CITY OF WEST LAKE HILLS, TEXAS
NOTICE OF CITY COUNCIL REGULAR MEETING
Wednesday, October 28, 2020 at 7:00 PM

Doucet & Associates, Inc. (Doucet), is pleased to submit this response letter to our September 29, 2020 engineering drainage report documenting the analysis of a partial easement release located at 2 Downie Place in West Lake Hills, Texas. Our response to Comments 3-8 are as follows in blue text.

Cross Section 4

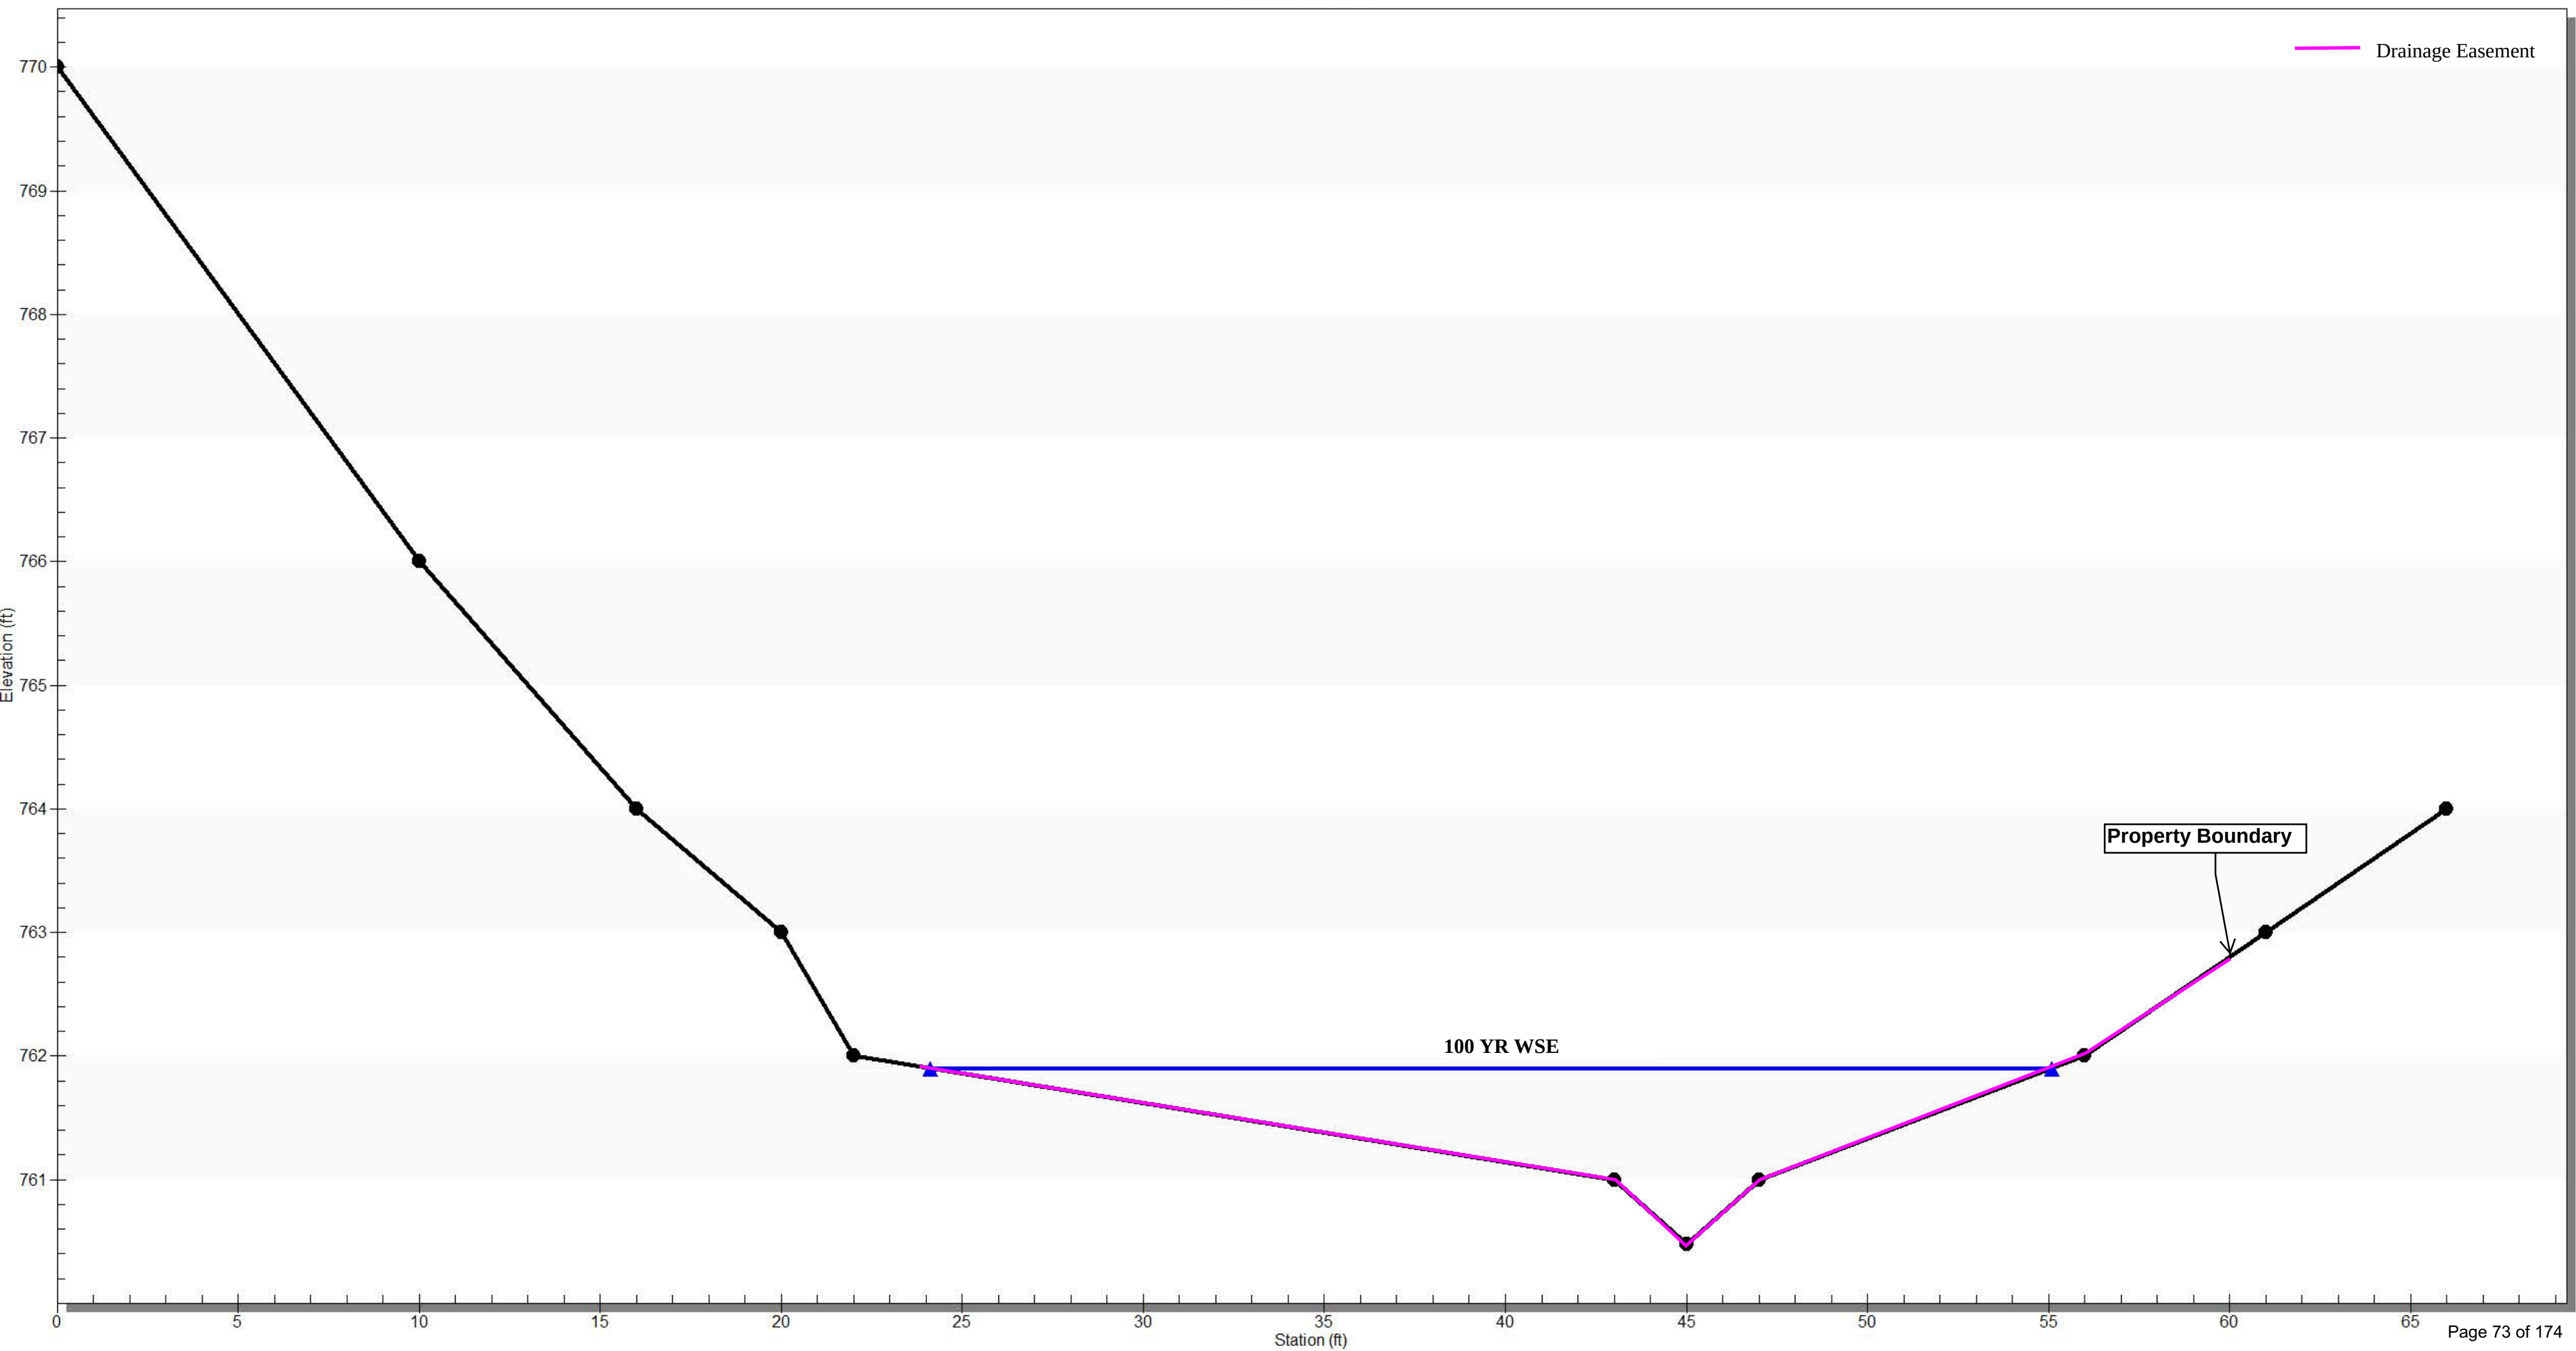
3. Please verify Easement overtopping elevations as they appear to be inconsistent with the survey provided.

3-C1) Please show property line, existing, and proposed easement line in the cross section to verify overtopping elevations.

7-C1) Please show property line, existing easement line, and proposed easement line in the cross sections.

Response: Easement lines and property boundary has been added to cross sections.

Response: Easement lines and property boundary has been added to cross sections.

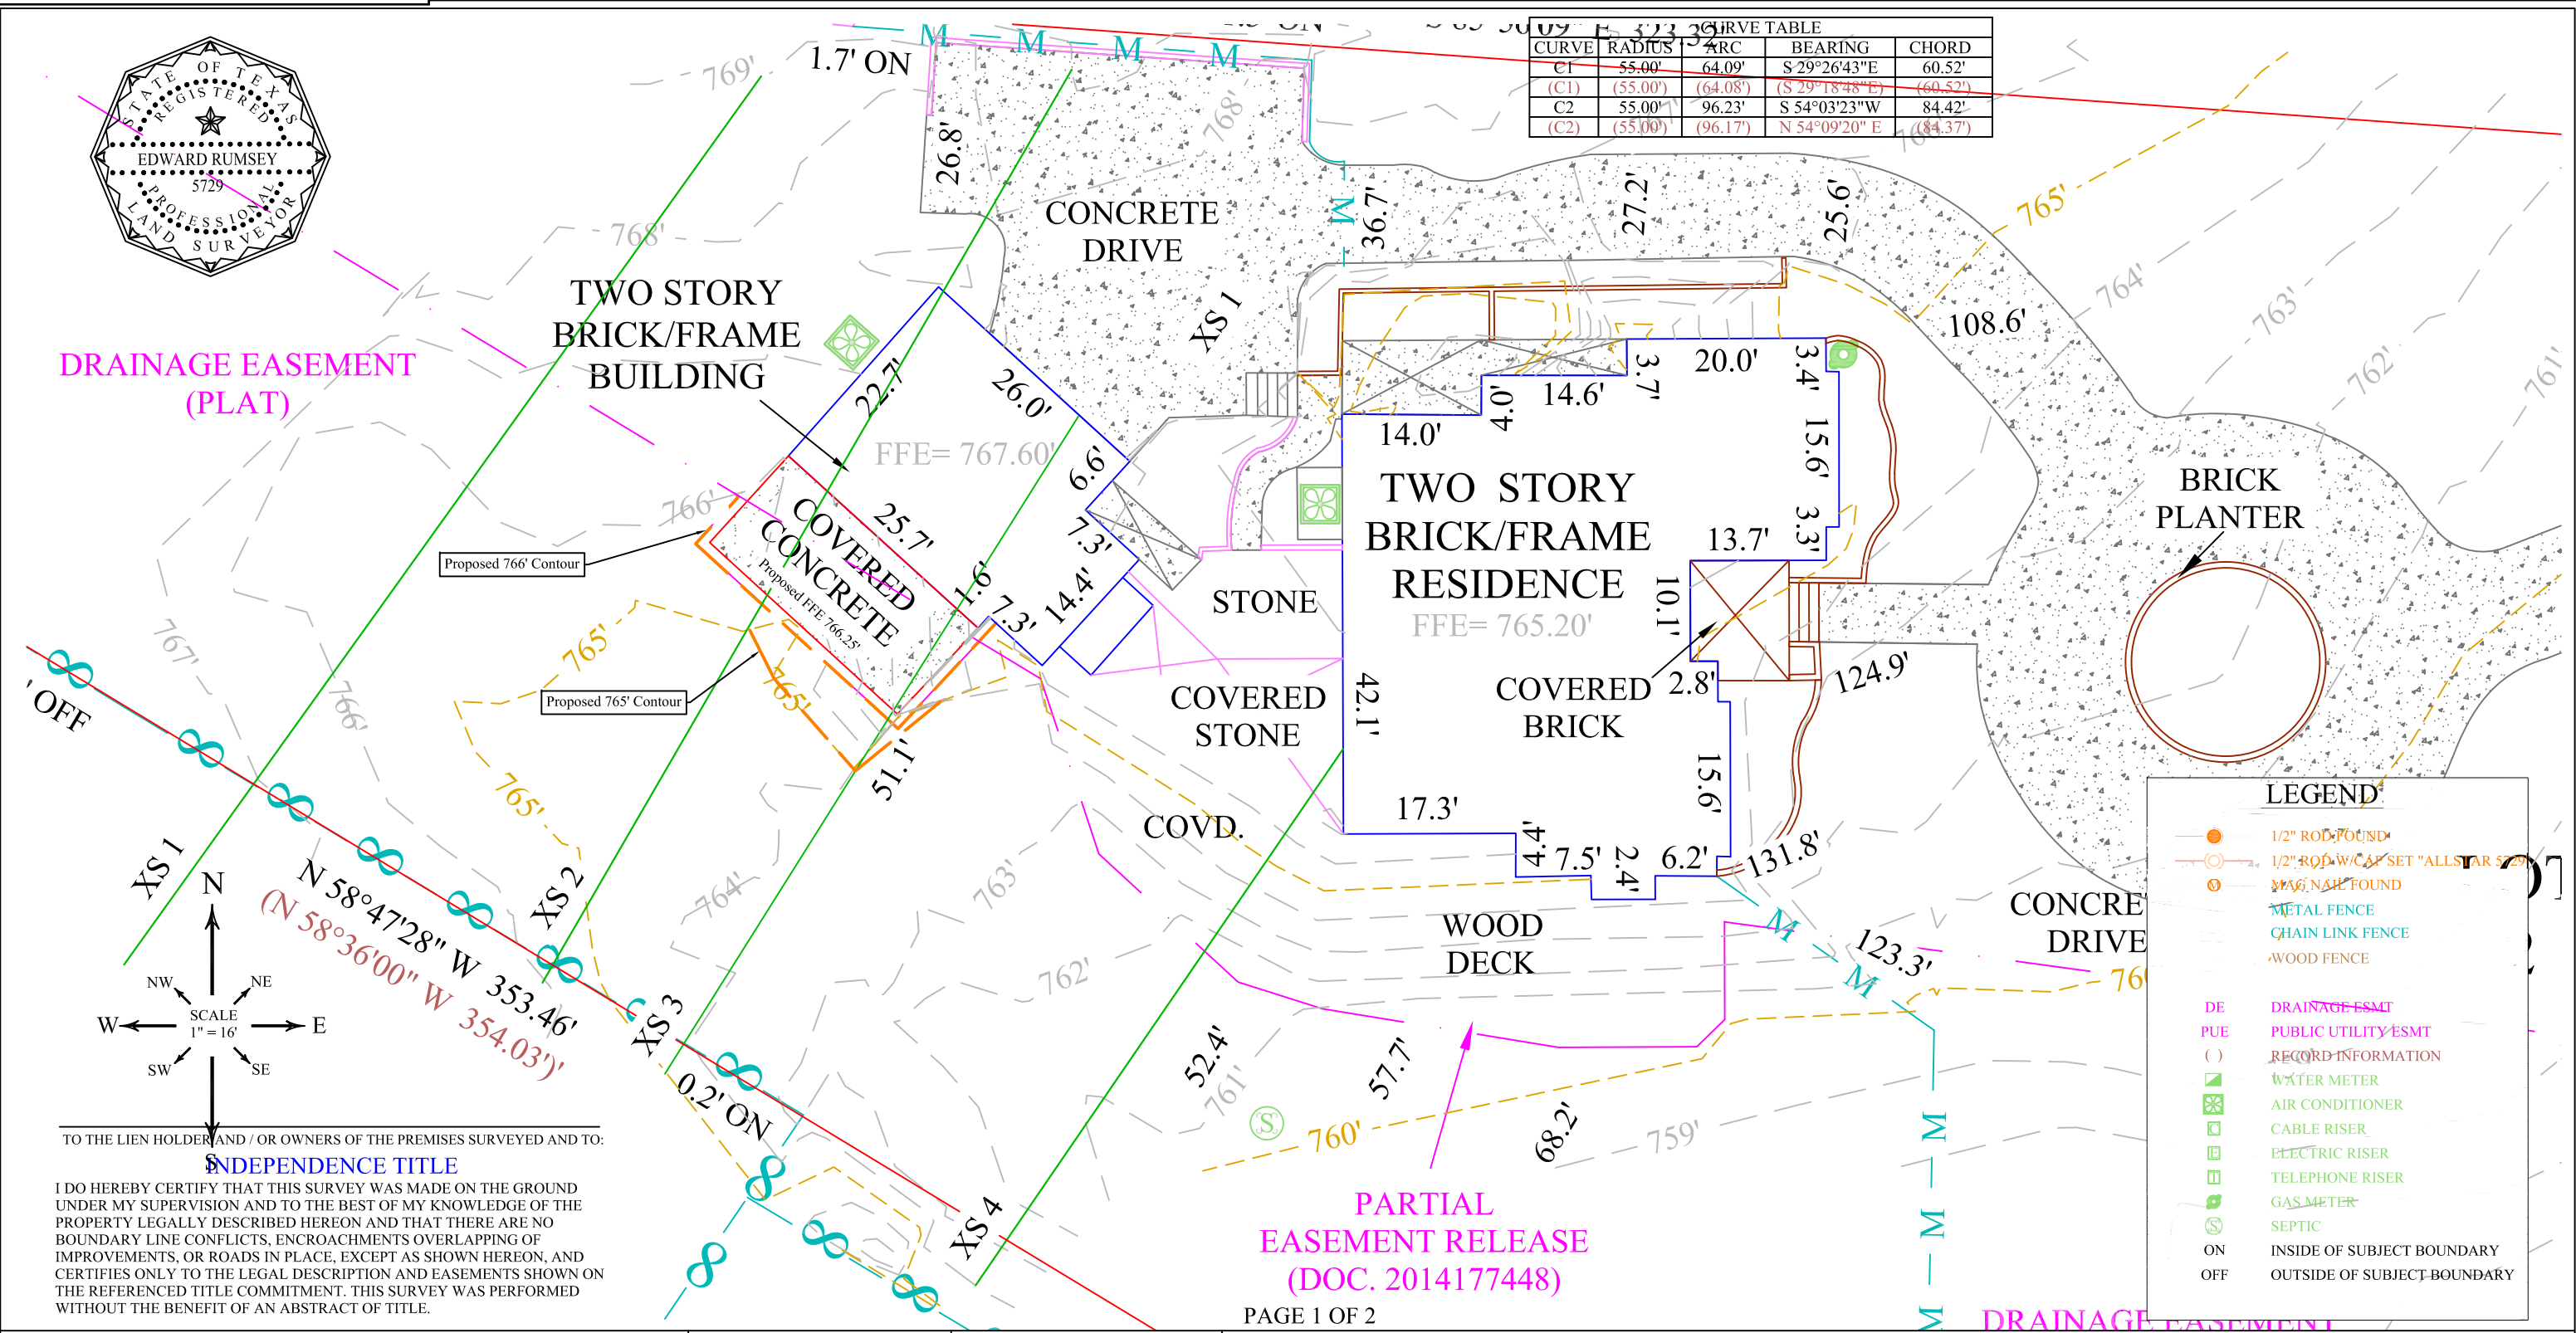
8. Please provide a grading plan for proposed improvements.

Response: Grading plan provided
